Date: February 11, 2016
To: Mayor Kathleen Hoertkorn and Council Members
From: Heidi Scoble, Planning Manager
Subject: Cypress Trust Design Review Amendment, 38 Fernhill Avenue, File No. 2016-005

Town Council approval of Resolution 1936 to allow architectural design modifications, including the use of a cedar roofing material, for the new construction of a single family residence at 38 Fernhill Avenue, APN 073-041-37.

38 FERNHILL AVENUE
 ROSS, CALIFORNIA
 JANUARY 14, 2016
 PERMIT REVISION

A2.11

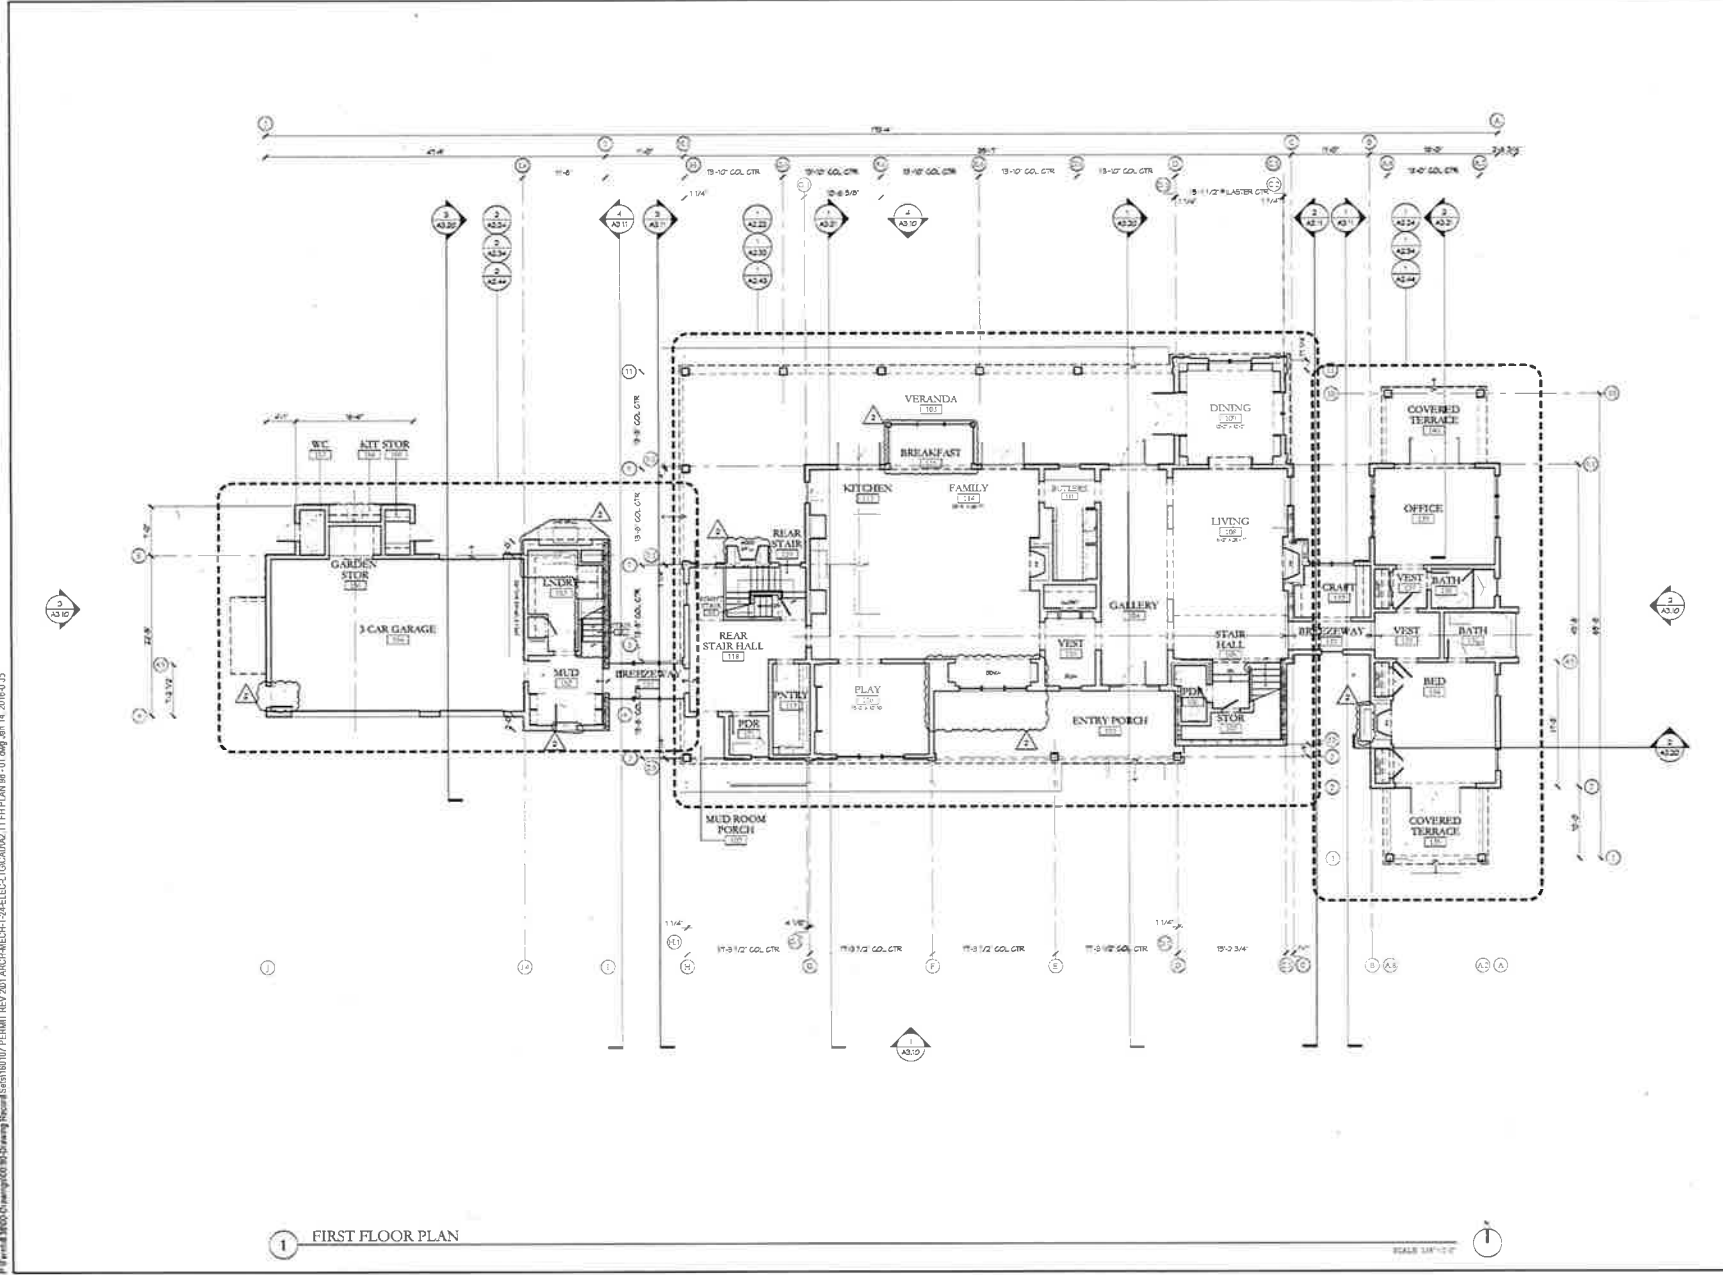
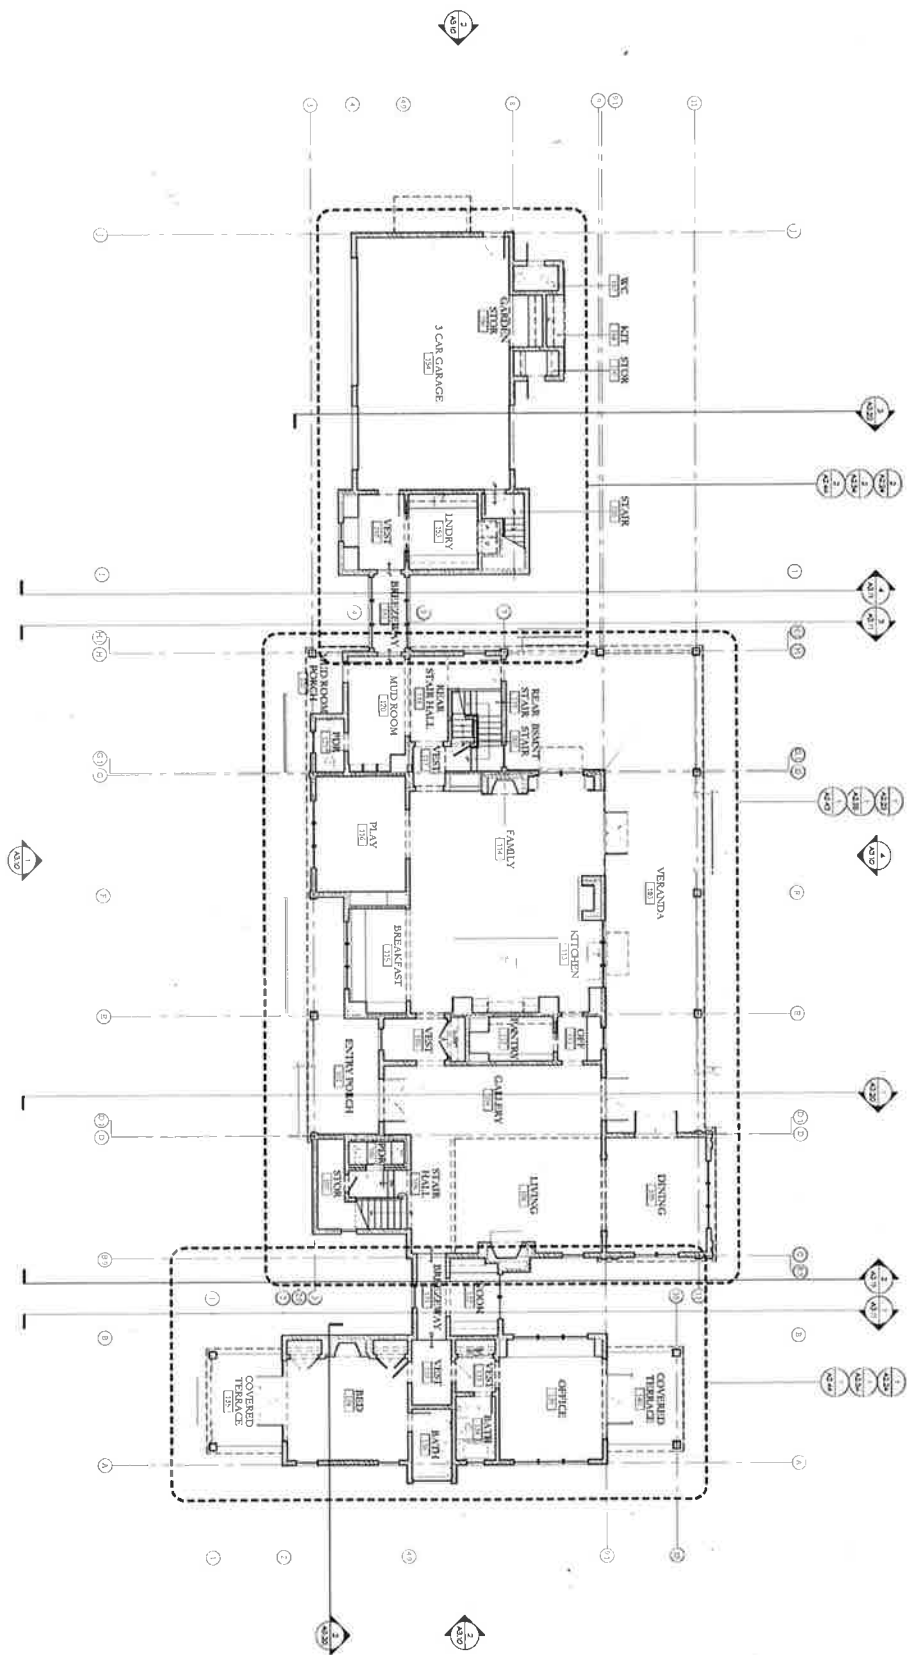
- ✓ Modify interior floor plans
 - ✓ Relocate the breakfast bay from the south side of the room to the north side of the family room
 - ✓ Relocate the kitchen

- Breakfast bay moved from south side to north side of family room
- Family room layout mirrored to move kitchen to west wall
- Column spacing along north edge of veranda reconfigured
- Laundry room/stair to garage attic reconfigured
- Reconfigured closets/bath at master suite - bay added for shower
- Doors at master bath terrace reduced, added to bay
- Floor area of house reduced by 79 square feet

1 SECOND FLOOR PLAN

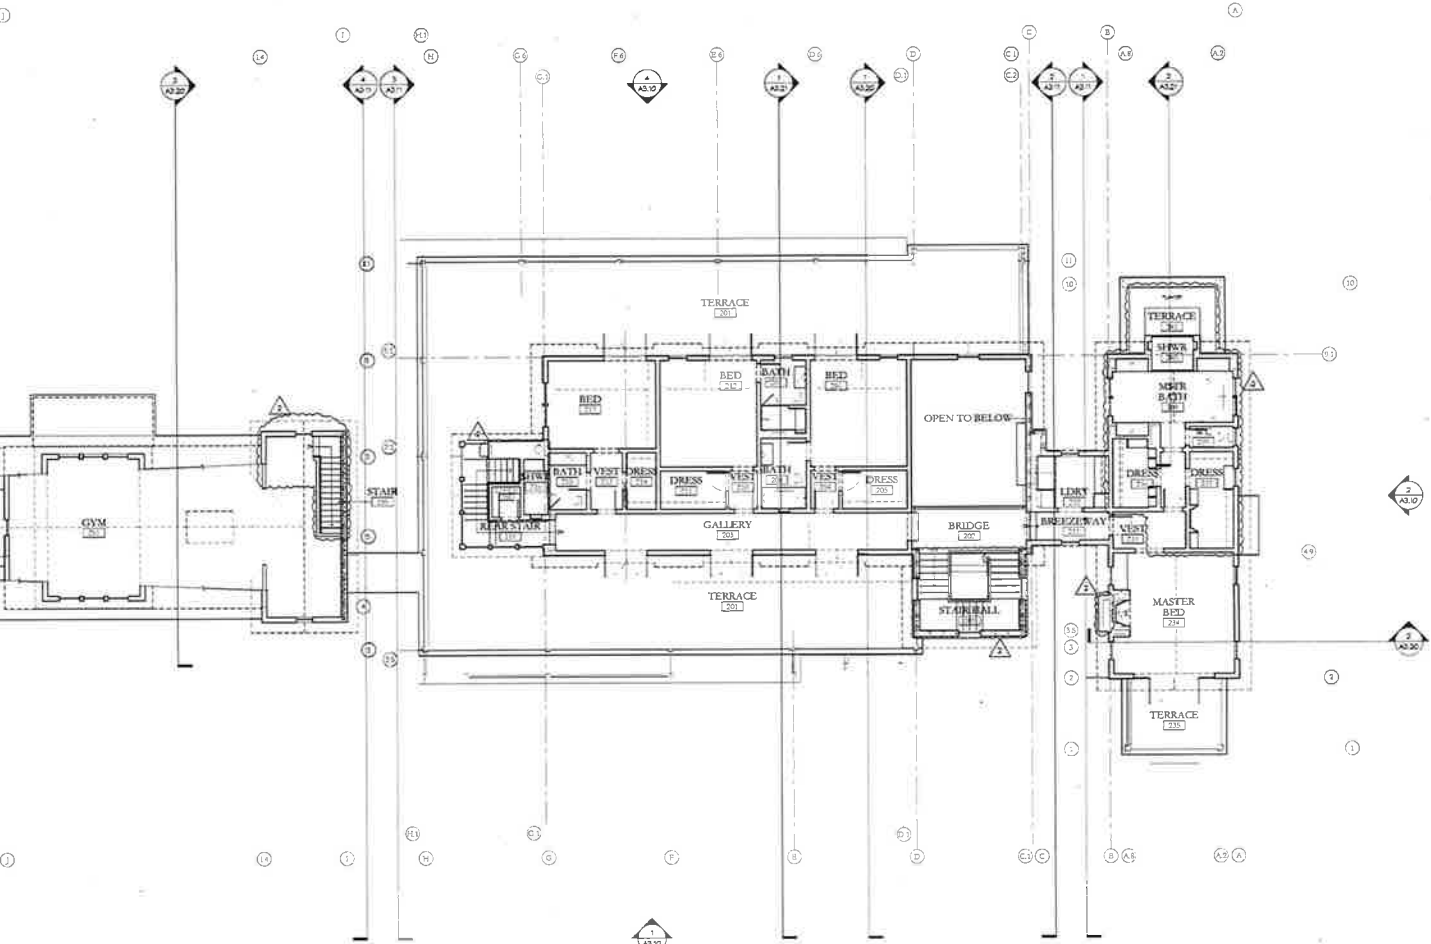
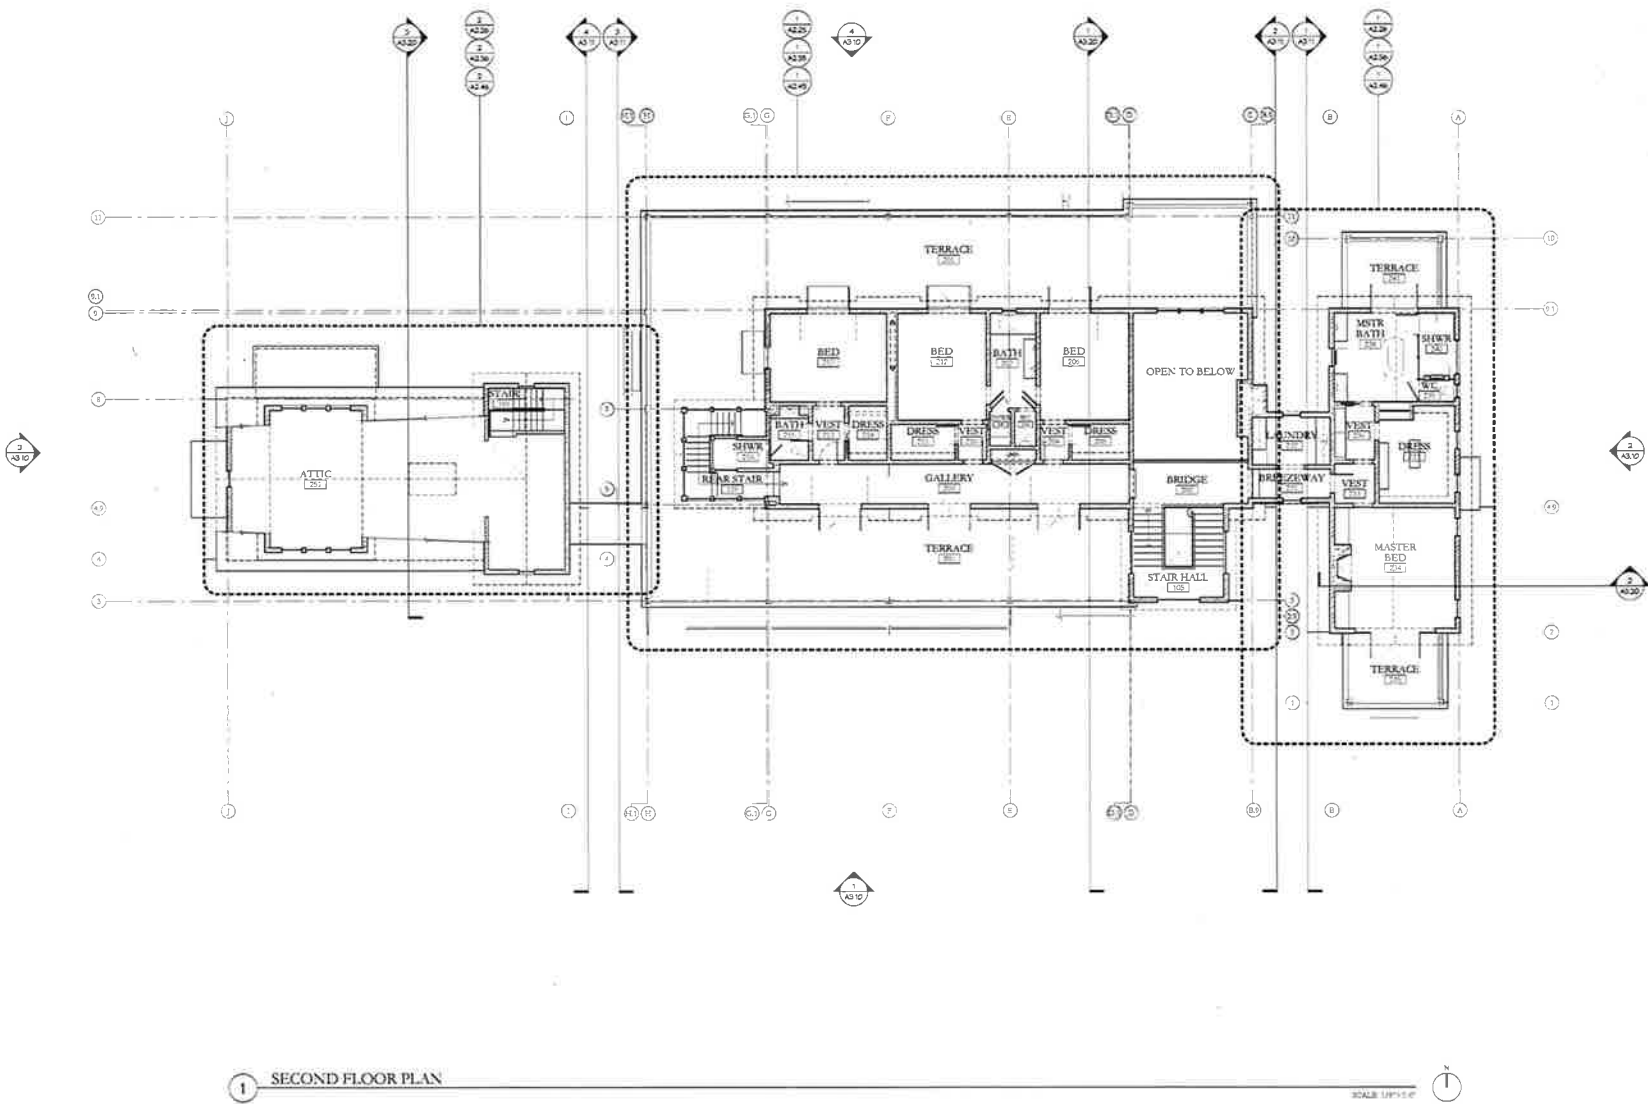
- ✓ Reconfigure the laundry room/stair to garage attic, reconfigure the closets and bath within the master suite, and reduce floor area

ROOF PLAN
SCALE: 1/8" = 1'-0"
A2.13
01.14.16

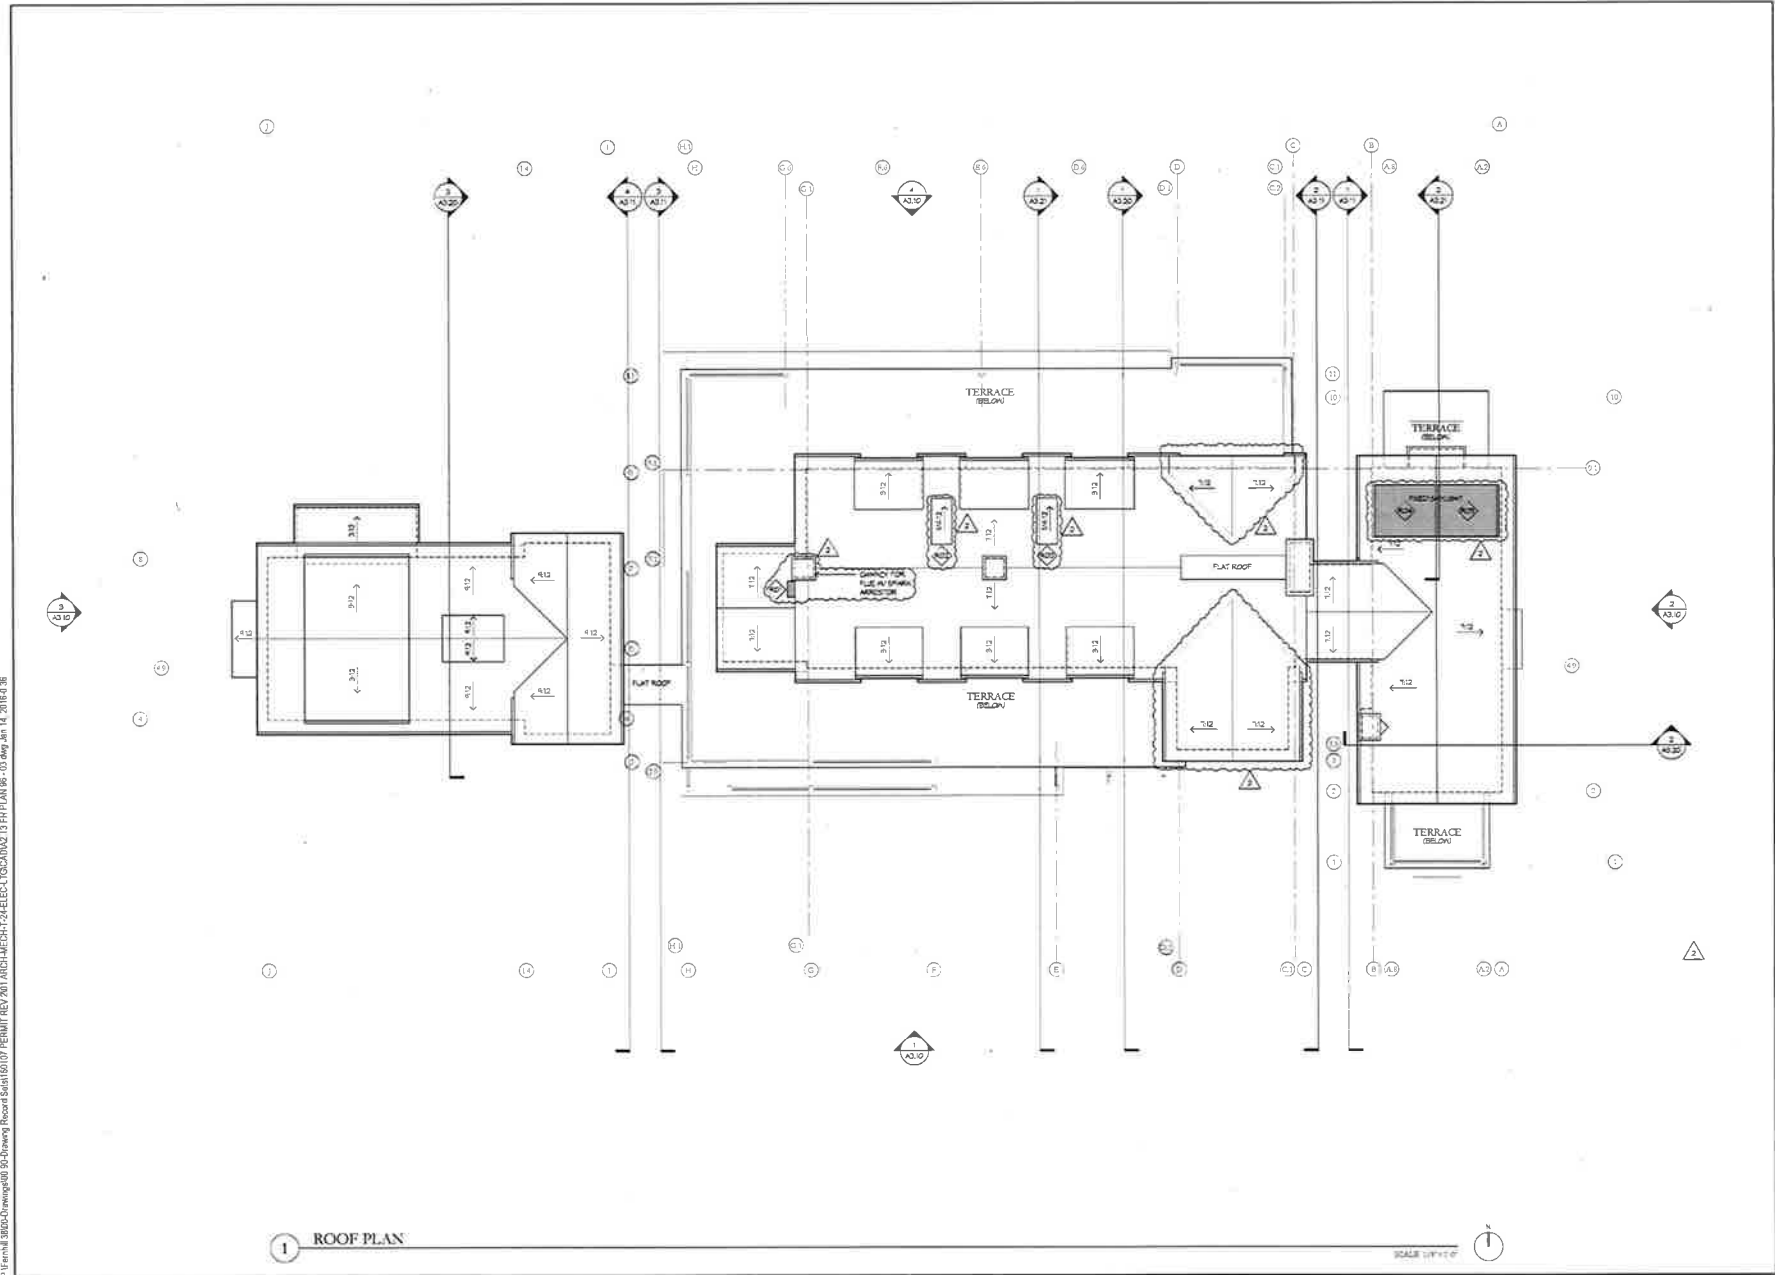
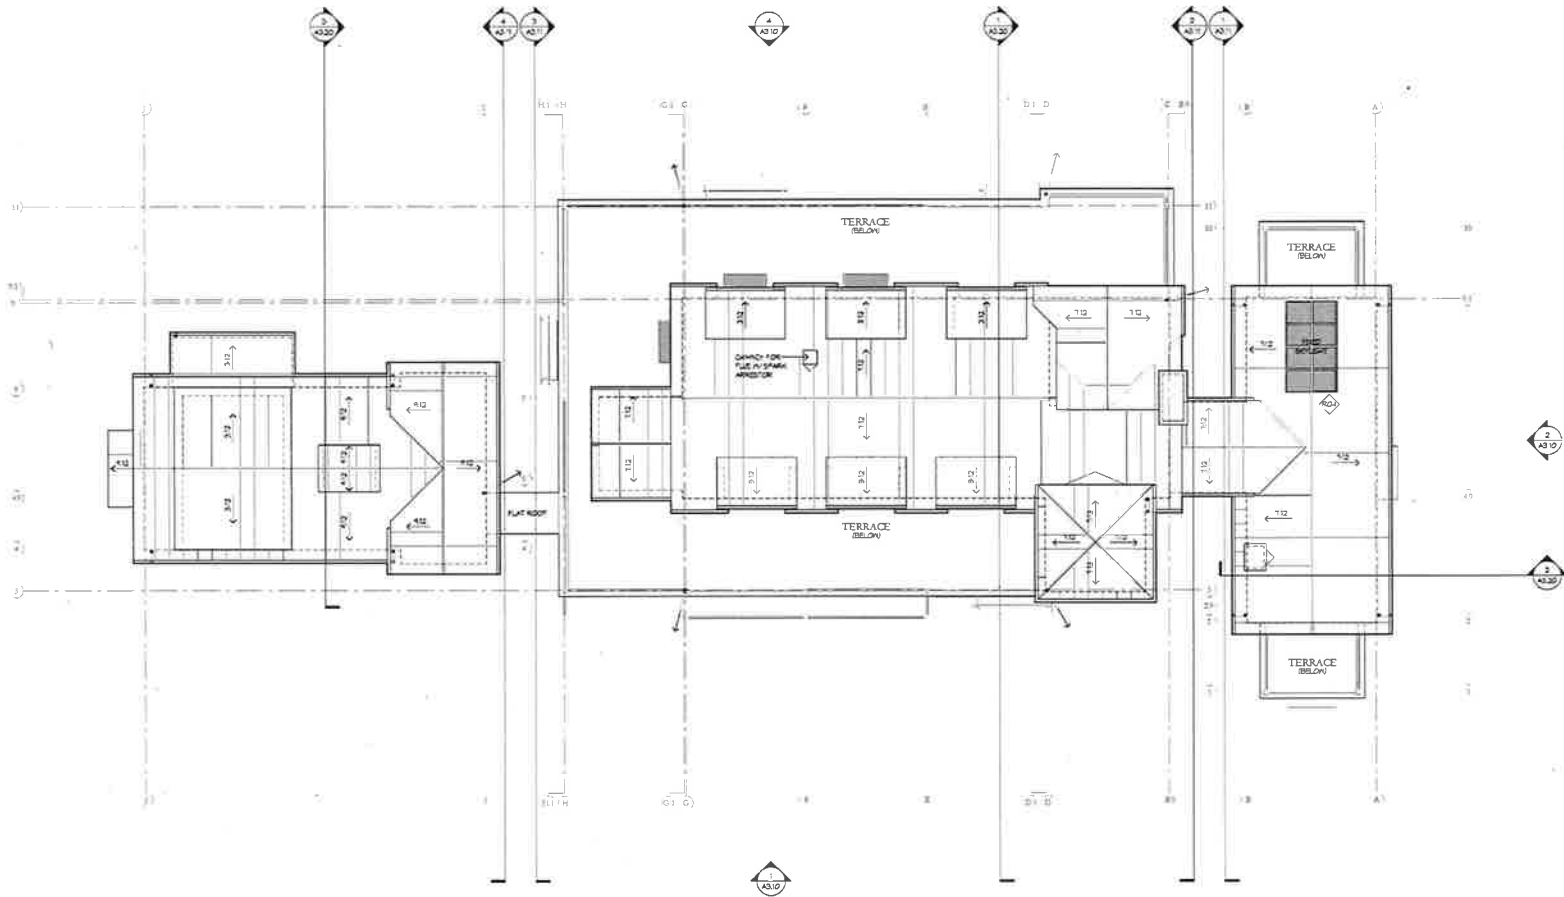
- ✓ Install new chimney
 - ✓ Install two reverse dormers on the north side of the main roof
 - ✓ Modify skylights
 - ✓ Modify stair tower from a pyramid to a gable roof with a lowered ridge

one area that warrants further discussion is the proposed cedar roofing material. The Town requires a Class A roof for all new construction. Although the applicant is proposing a Class B cedar shingles, the shingles would be treated with fire retardant material that would be installed over a 72lb mineral cap sheet over an asphalt-impregnated roofing felt underlayment, thus making Class A roof by assembly. A Class A roof by assembly is permitted by the building codes.

- Stair tower roof changed from pyramid to gable with lowered ridge
- Dormer over living room reduced/ridge lowered
- Skylight R04 reconfigured per master bath plan change
- Three skylights removed from upper terrace floor
- Skylight R01 added above shower 216
- Two small reverse dormers R02, R03 added to north side of main roof
